**CITY OF ROCKWALL  
HISTORIC PRESERVATION ADVISORY BOARD (HPAB) CASE MEMO**

**AGENDA DATE:** 05/18/2017

**AGENDA ITEM:** H2017-006 510 Williams Street-COA

TITLE:  
ELEVATION - RESIDENCE

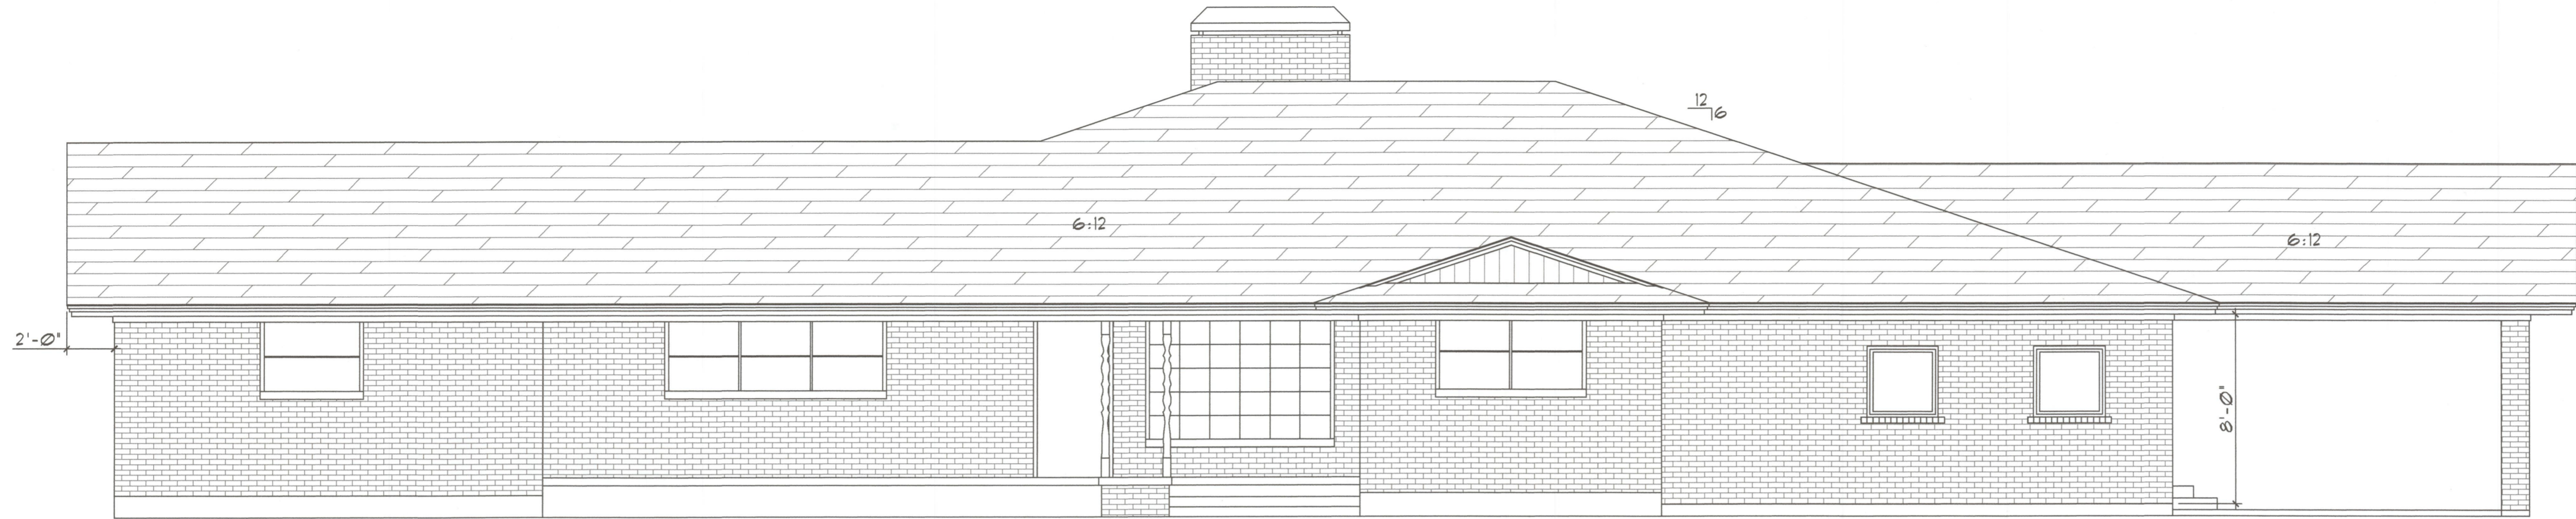
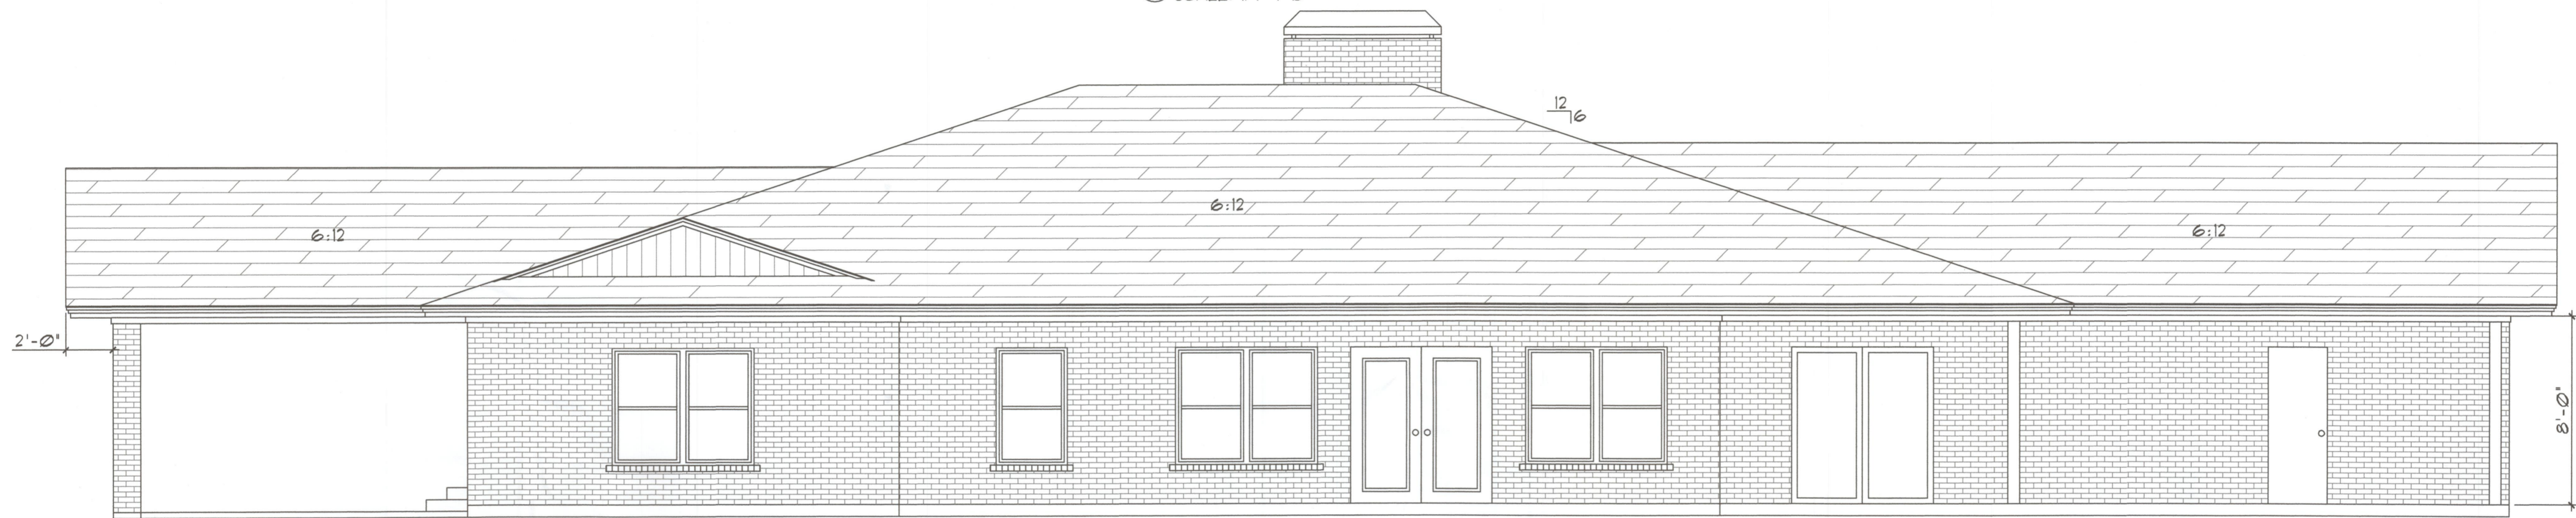
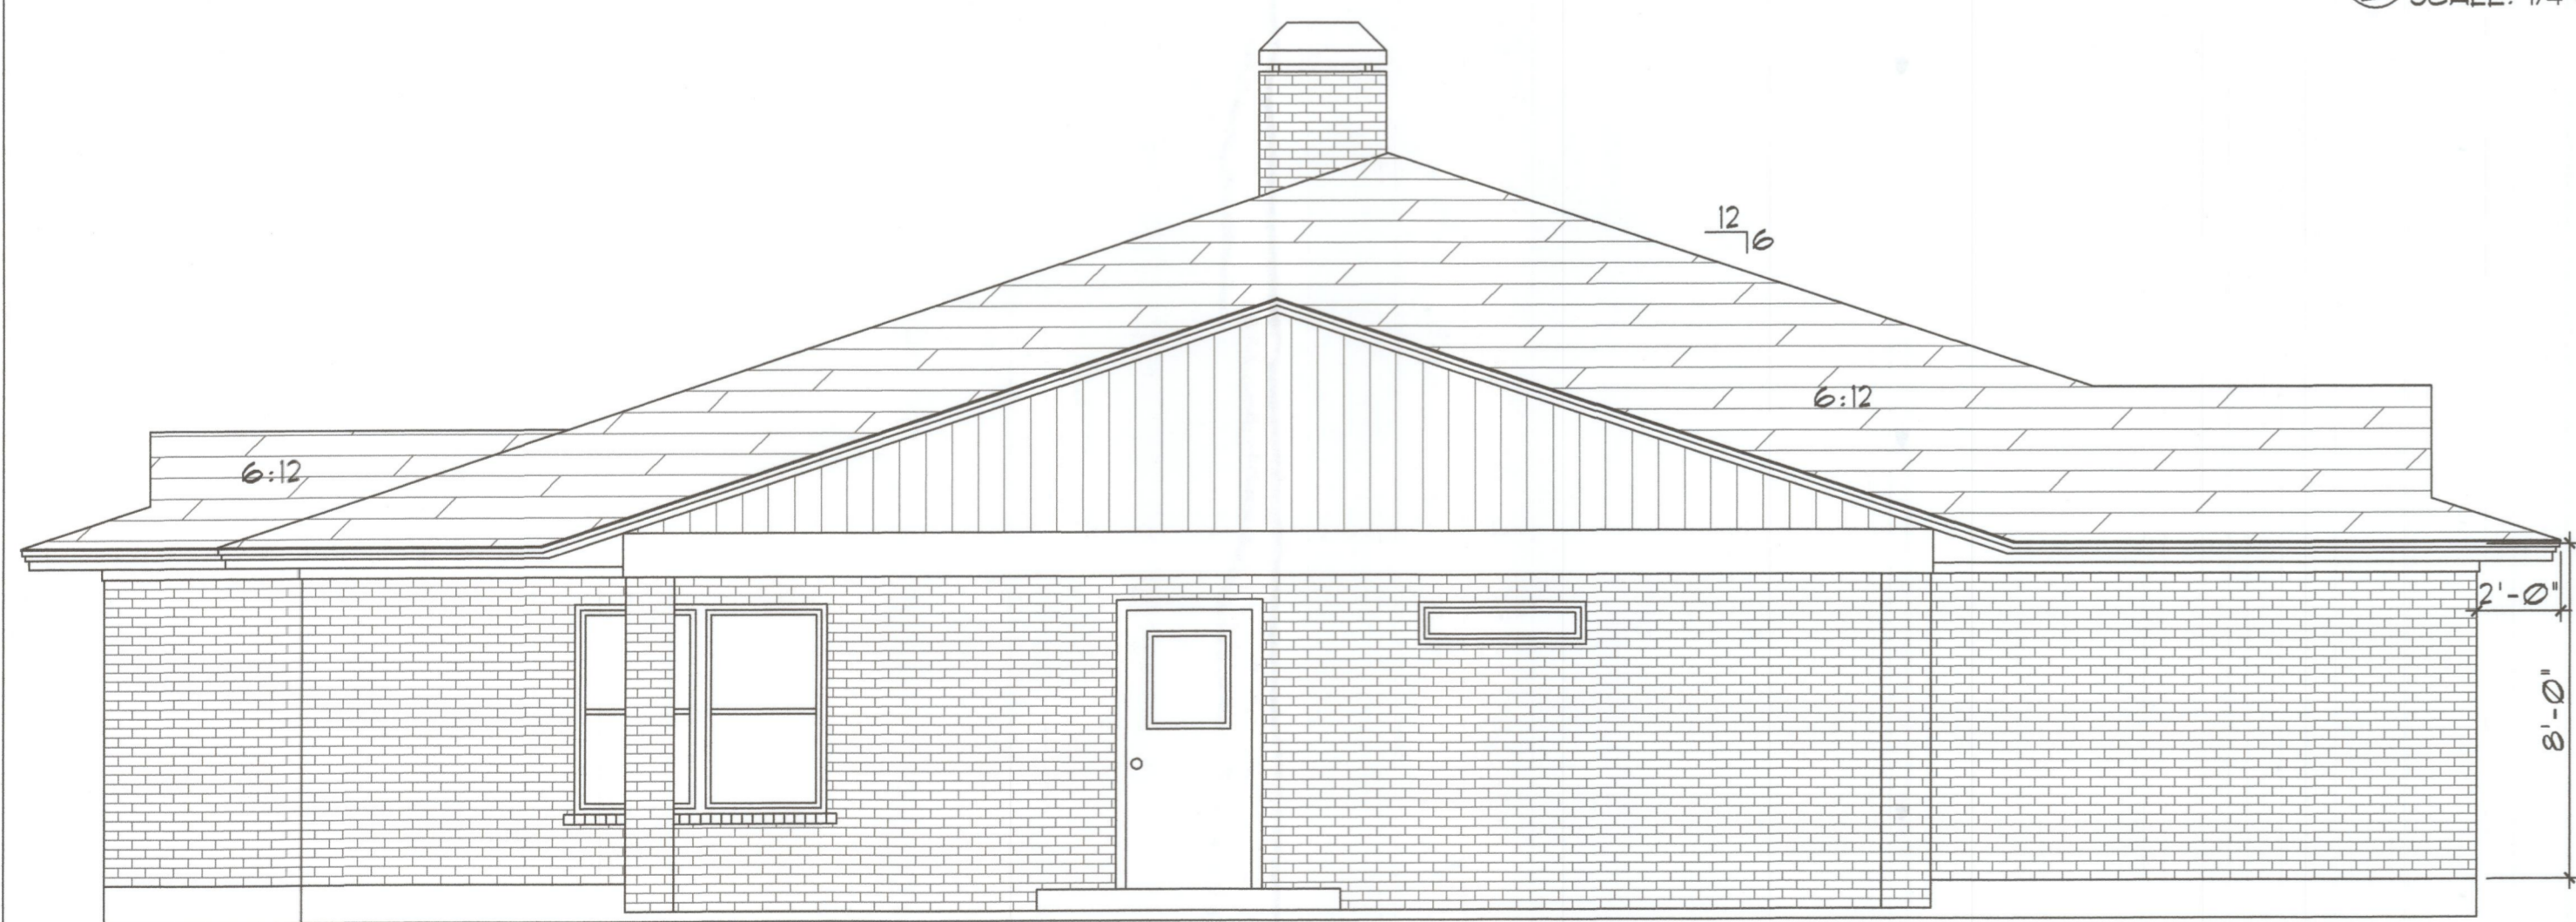
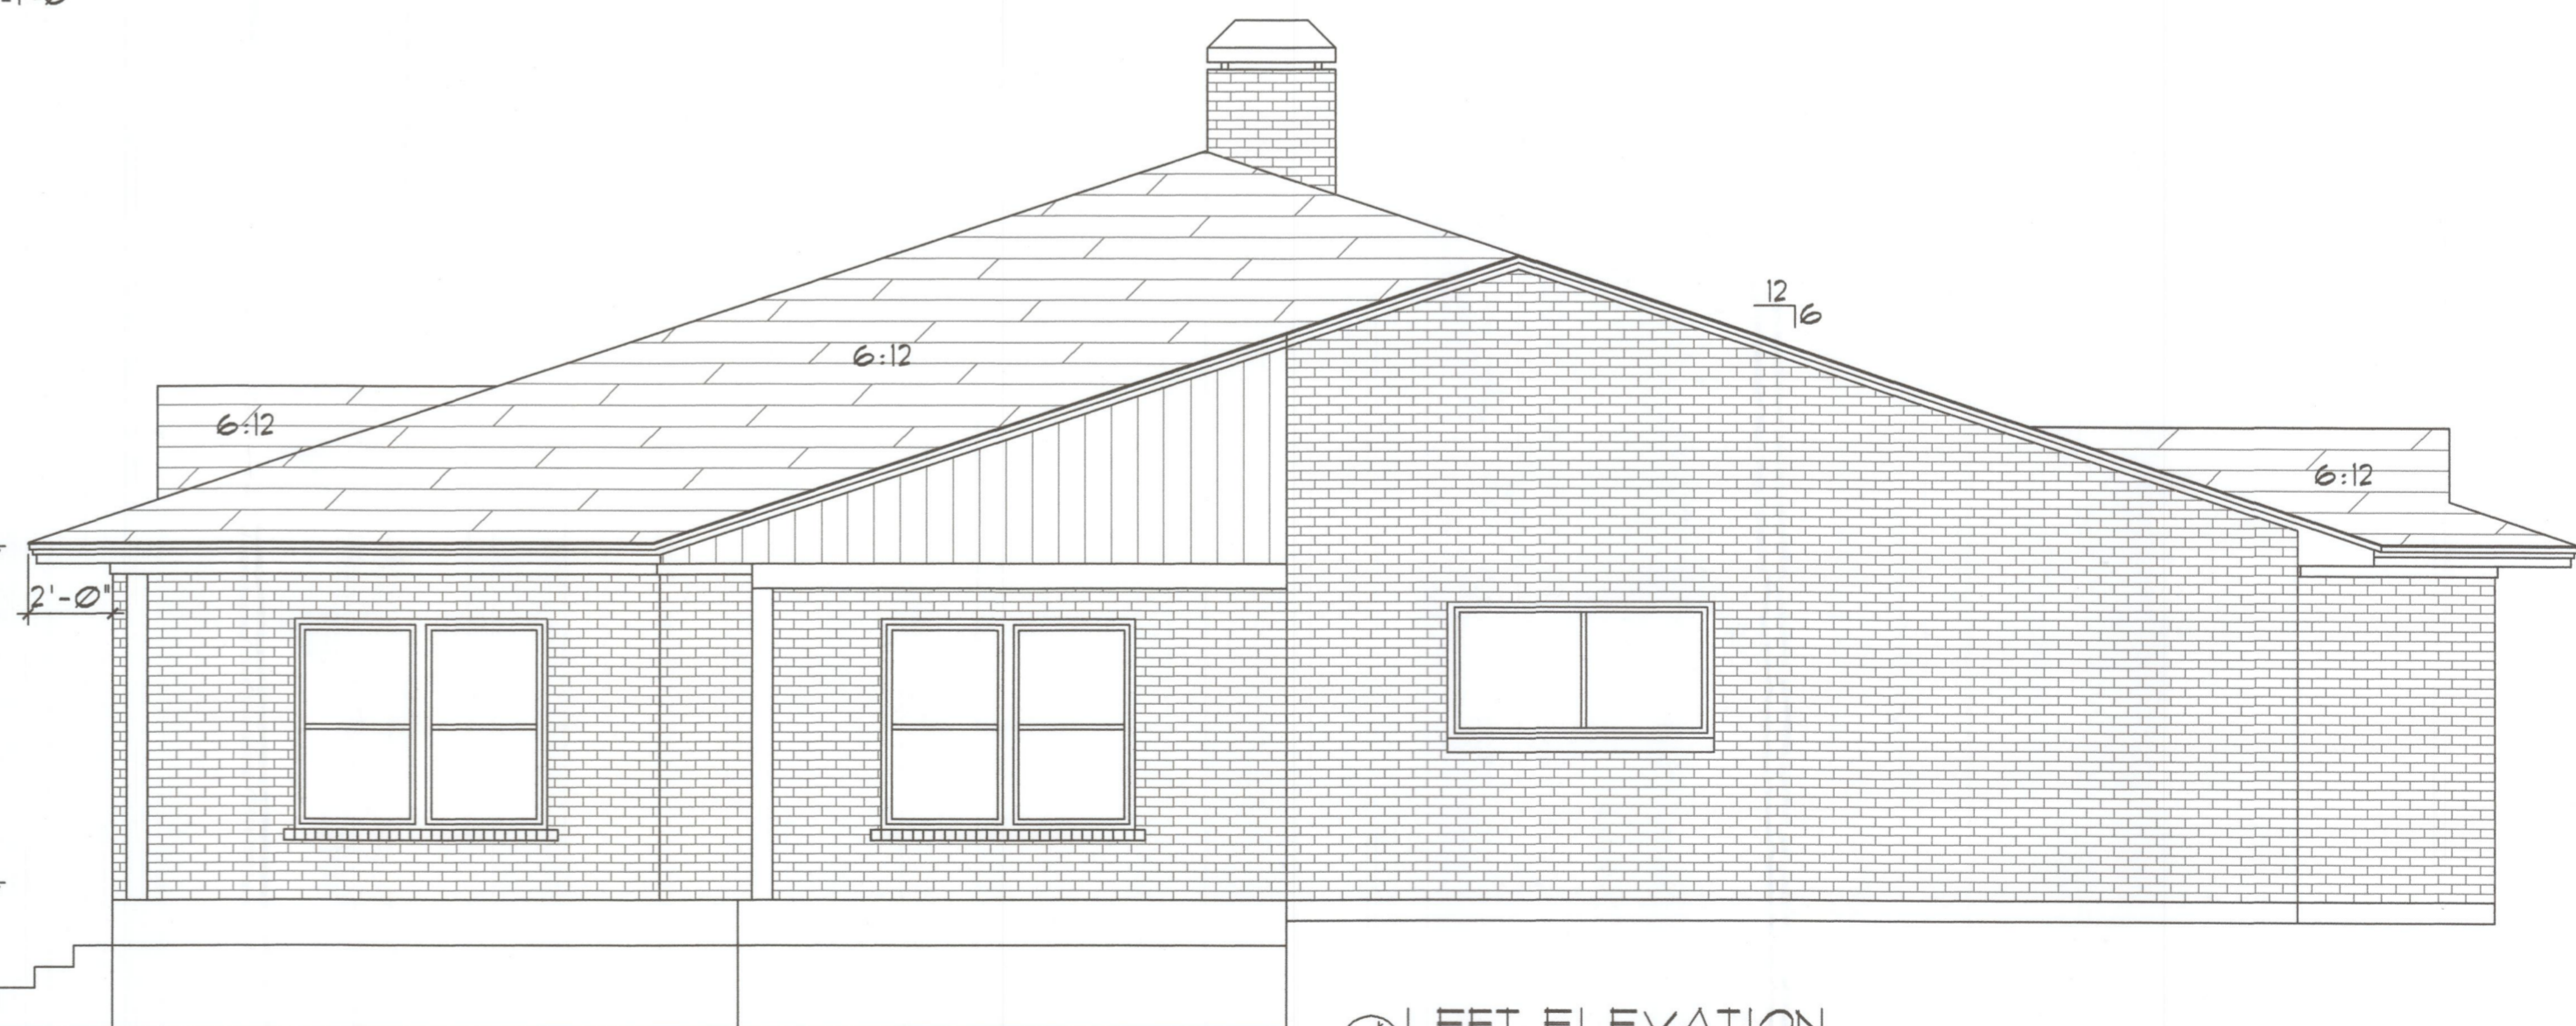
- ☒ *Roof shape, form and design should be typical of or consistent with the style and period of the architecture of buildings within the Historic District. **Although the roofline is being changed, the proposed roofline is consistent with the style and architecture of the period.***

- ☑ *The accepted roof overhang for a new structure should be typical of a structure of similar style and period. Replacement, addition or alteration to an existing roof should have the same overhang as the existing roof. **The proposed roof overhang is typical of a structure of similar style and period. Additionally, the addition will match the roof of the existing structure.***

- ☑ *The eaves or soffit heights of a structure should be consistent with the heights of neighboring contributing structures or with those in the closest block face with buildings of a similar period and style and the same number of stories. **The proposed soffit heights are consistent with neighboring structures.***

- ☑ *Roof materials/colors should be visually compatible and compliment the style and period of the structure. Where historically typical materials are no longer available, compatible alternatives will be allowed. **The proposed roof materials are compatible and compliment the style and period of the structure.***

- ☑ *The degree and direction of roof slope and pitch should be consistent with the style and period of the historic structure. **The pitch of the roof is being change from a 6/12 to an 8/12-9/12, however, this is still consistent with the style and period of the primary structure.***
